1. SUBMITTAL TYPE: (Is this a resubmittal? Yes ☐ No ☒)			
Deferred Submittal ☐	Addendum Number: 01	Revision Number:	CCD Number: Category A ☐ or B ☐
2. PROJECT INFORMATION:			
School District/Owner: San Beranrdo City USD		DSA File Number: 36 H7	
Project Name/School: Indian Springs HS - Health Center		DSA Application Number 04 123900

ADDENDUM NO. 1

Indian Springs High School – Health Center

DSA #04-123900 FILE #36-H7 RCA Project No. 1-78-50

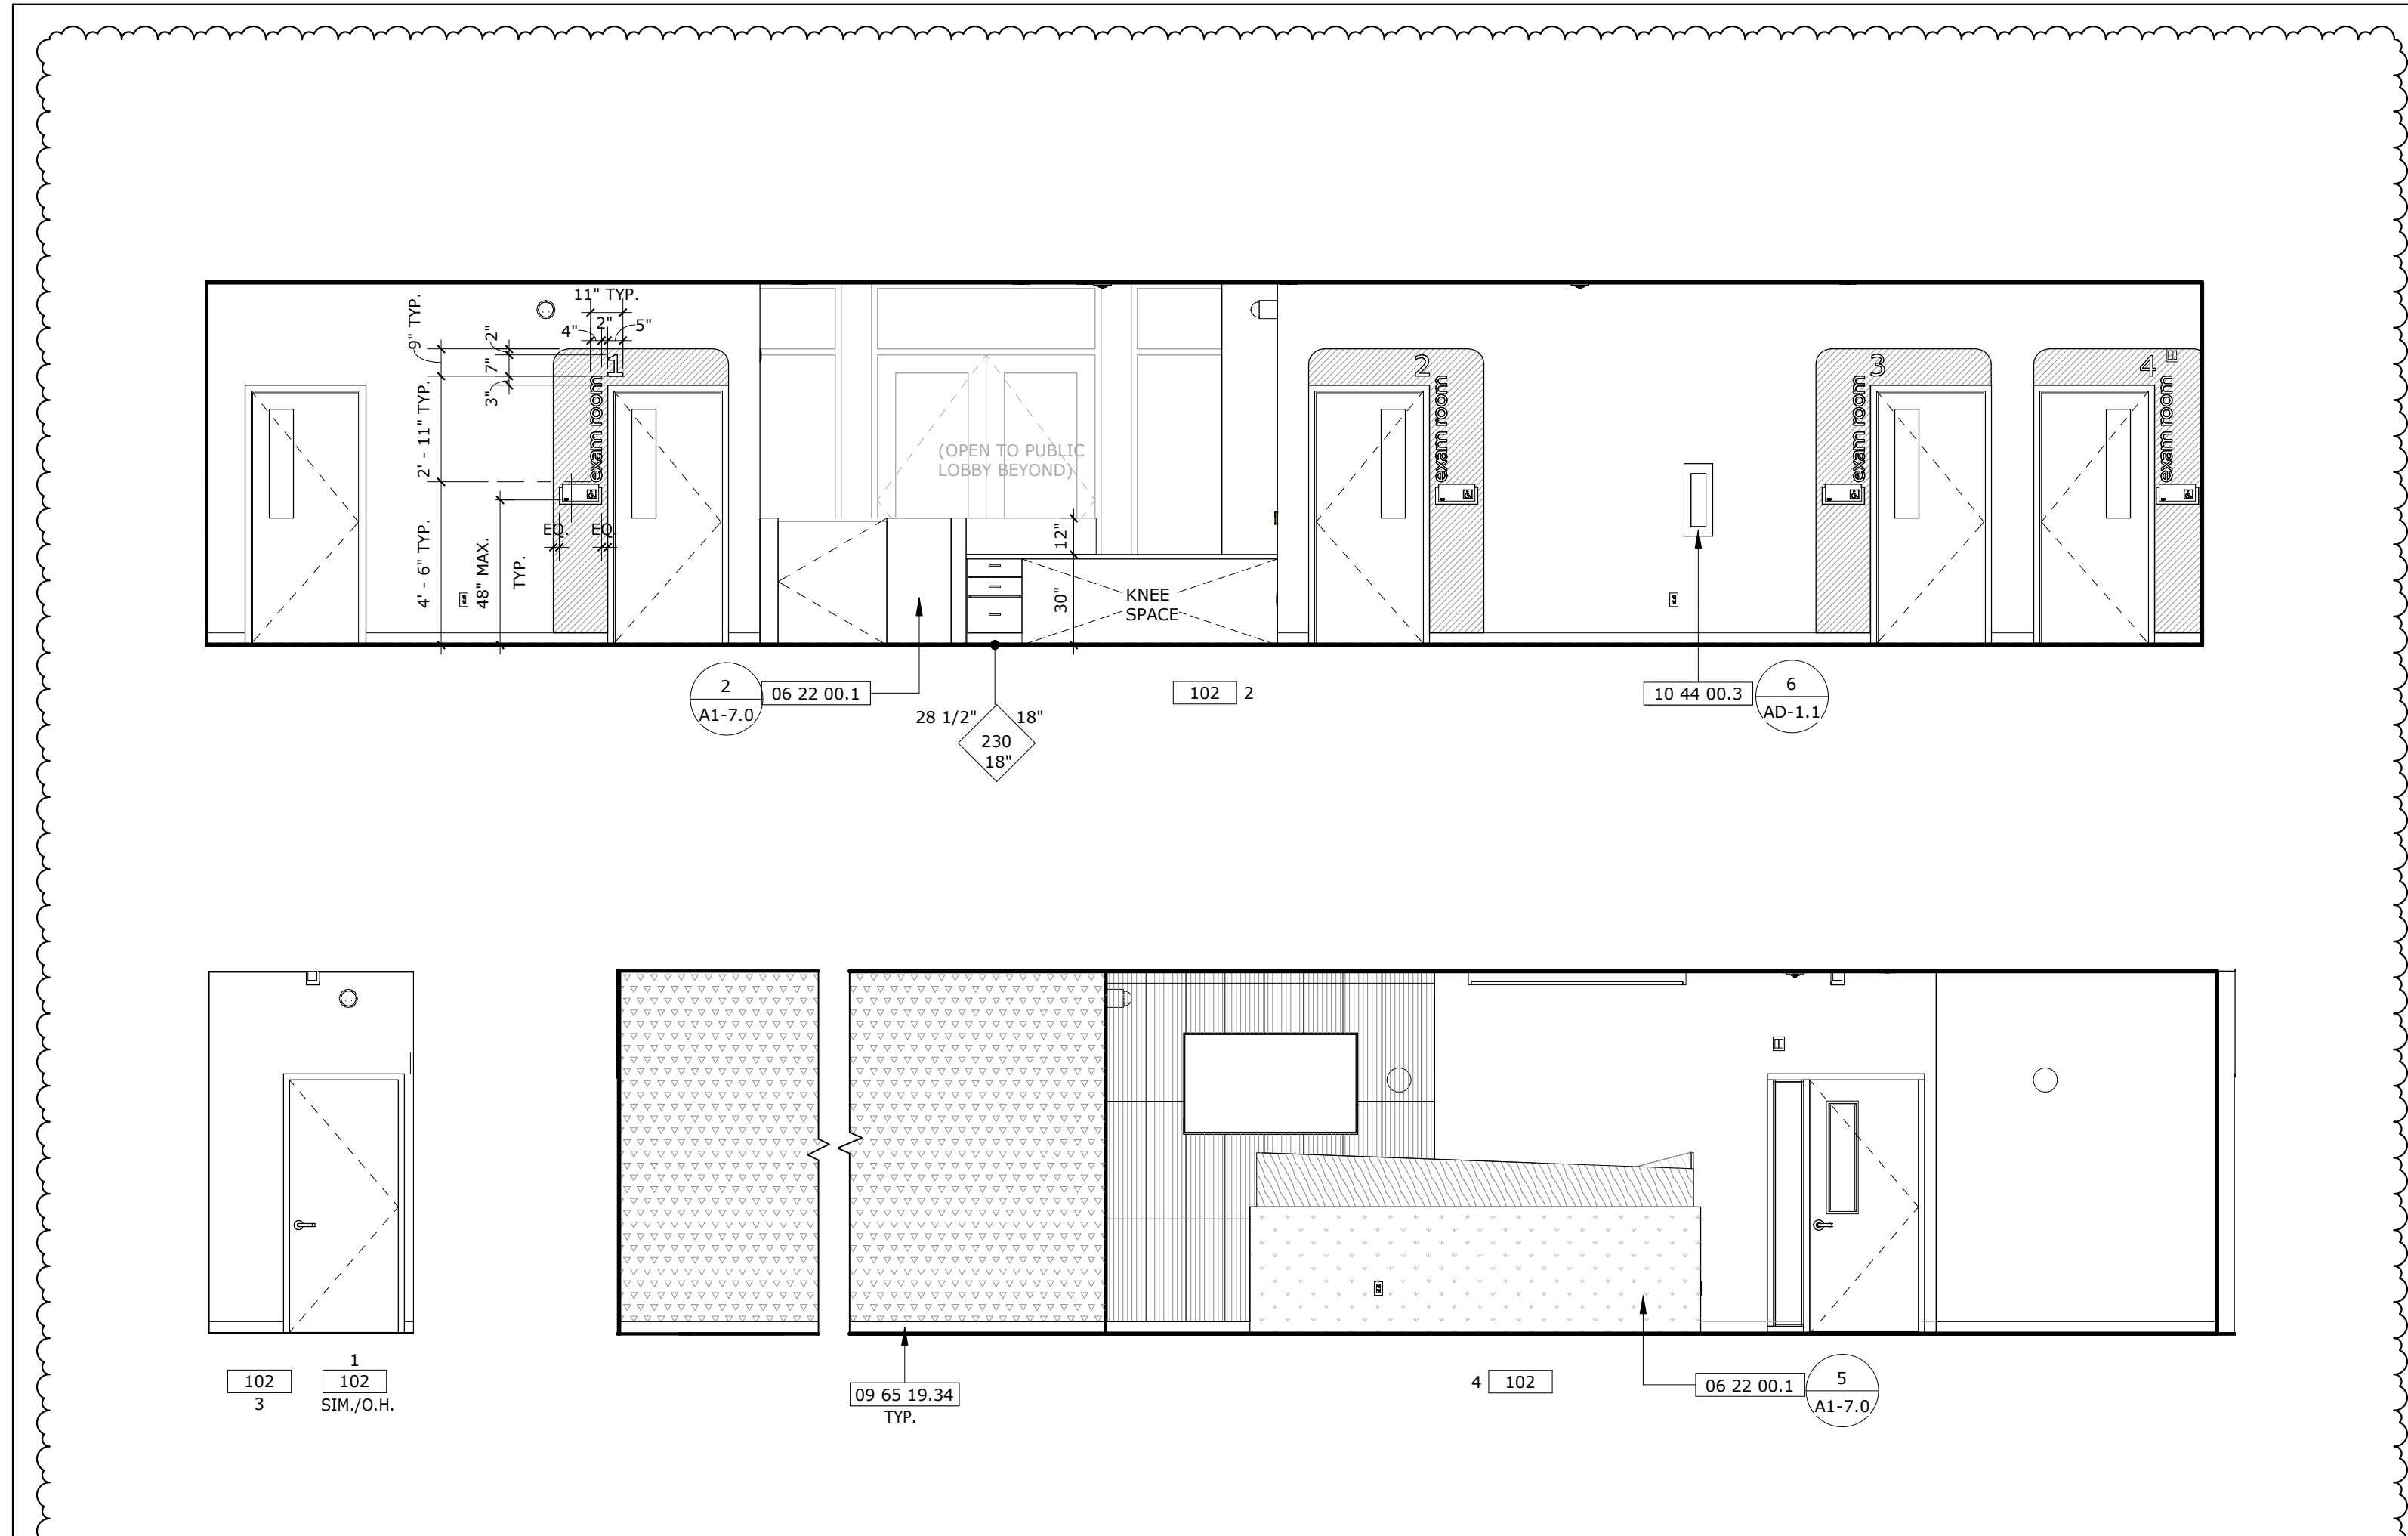
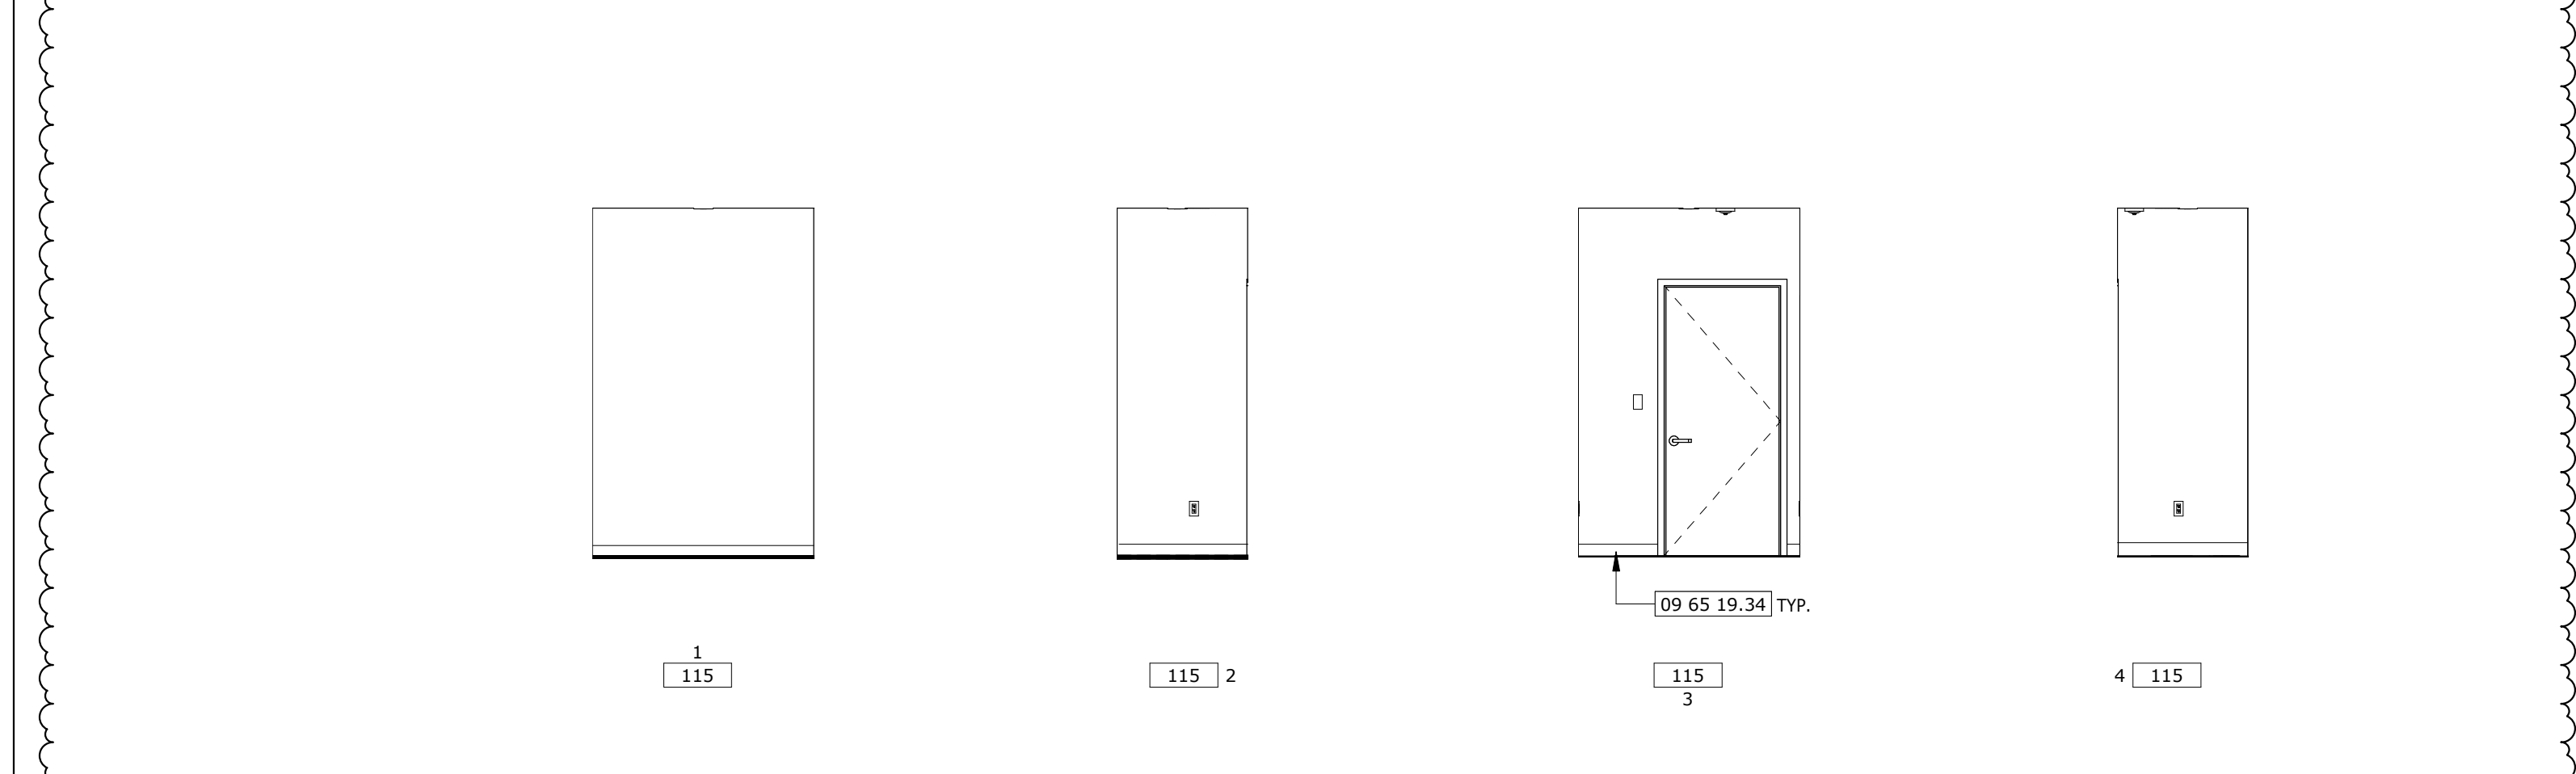
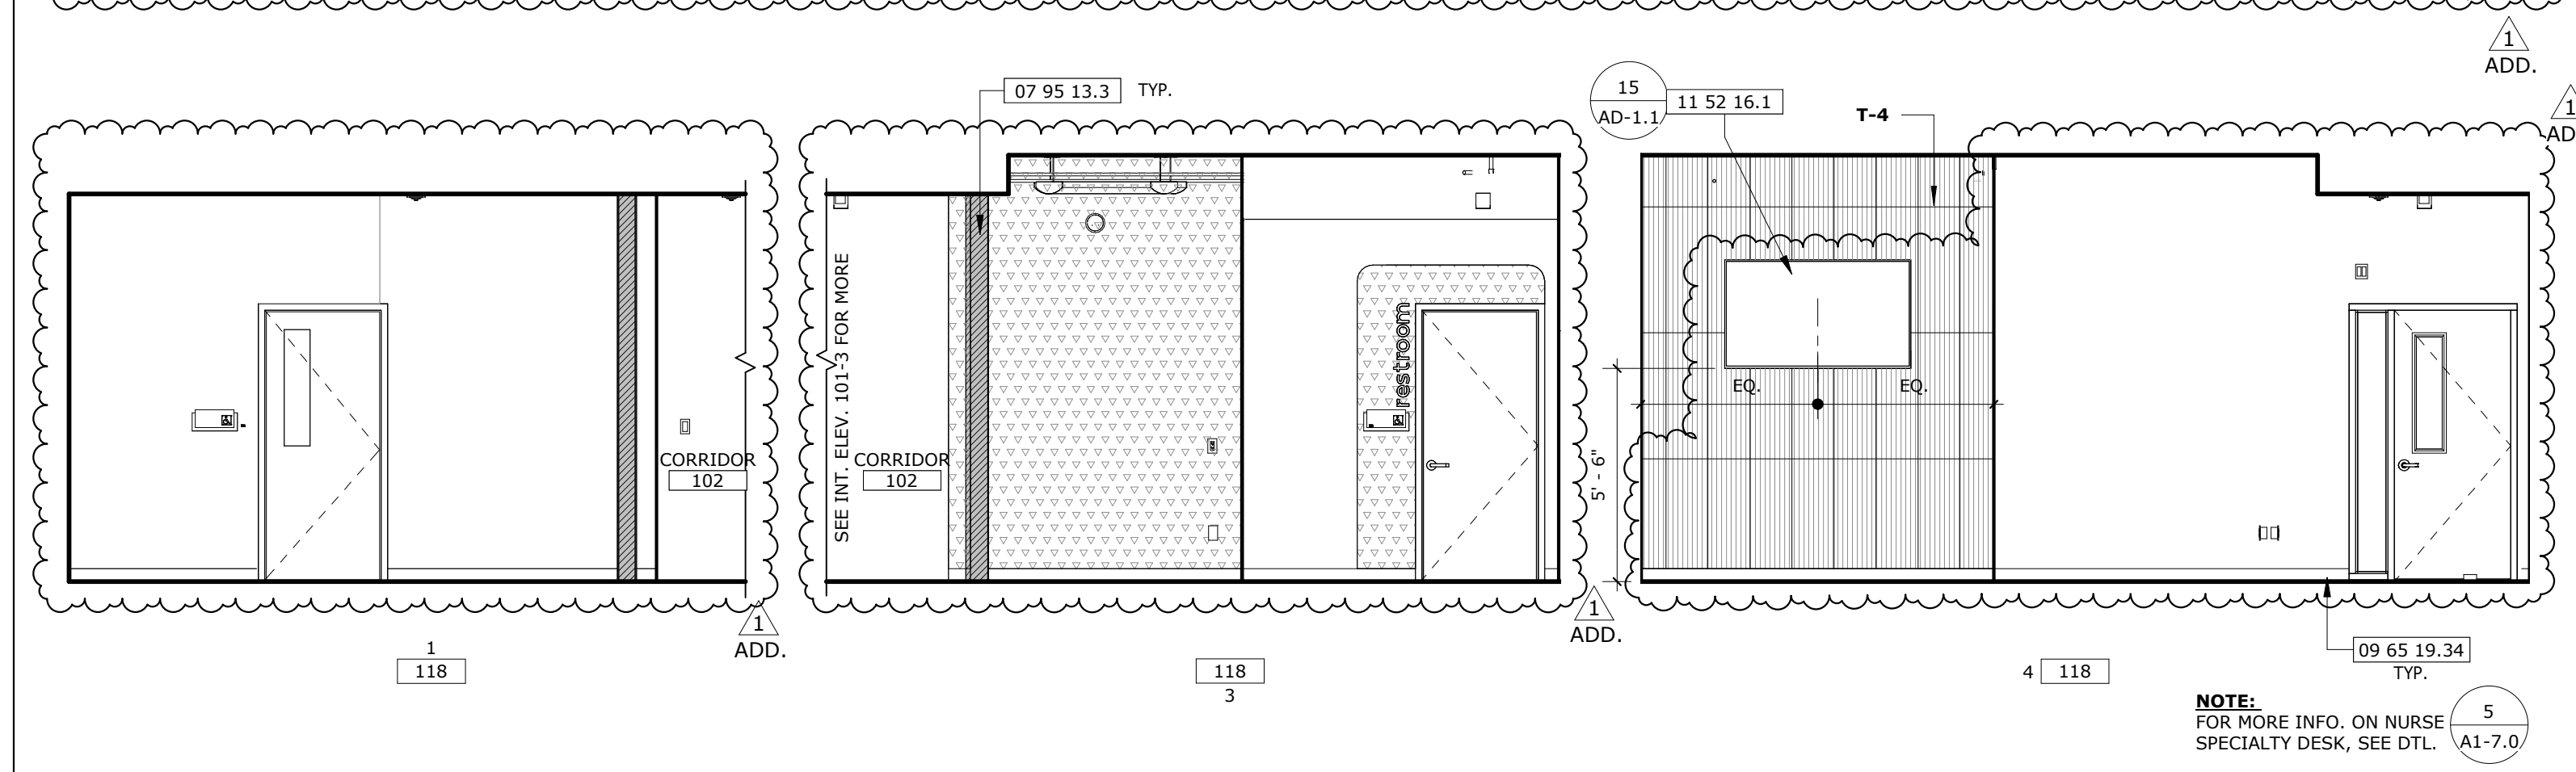
1.14.1 Replace Sheet A1-7.0 and revise per clouded areas & items listed below:
 (a) Detail 1, revised to reflect new restroom location on revised floor plan layout

(b) Detail 2, reduced size of Lobby Reception Desk
 (c) Removed Detail 3, no longer applies to project
 (d) Detail 5, revised to reflect the revised floor plan layout

- Item No. 1.15 Reference Sheet A1-7.1 – INTERIOR ELEVATIONS
1.15.1 Replace Sheet A1-7.1 and revise per clouded areas & items listed below:
 (a) Revised Interior Elevations to reflect the revised floor plan layout
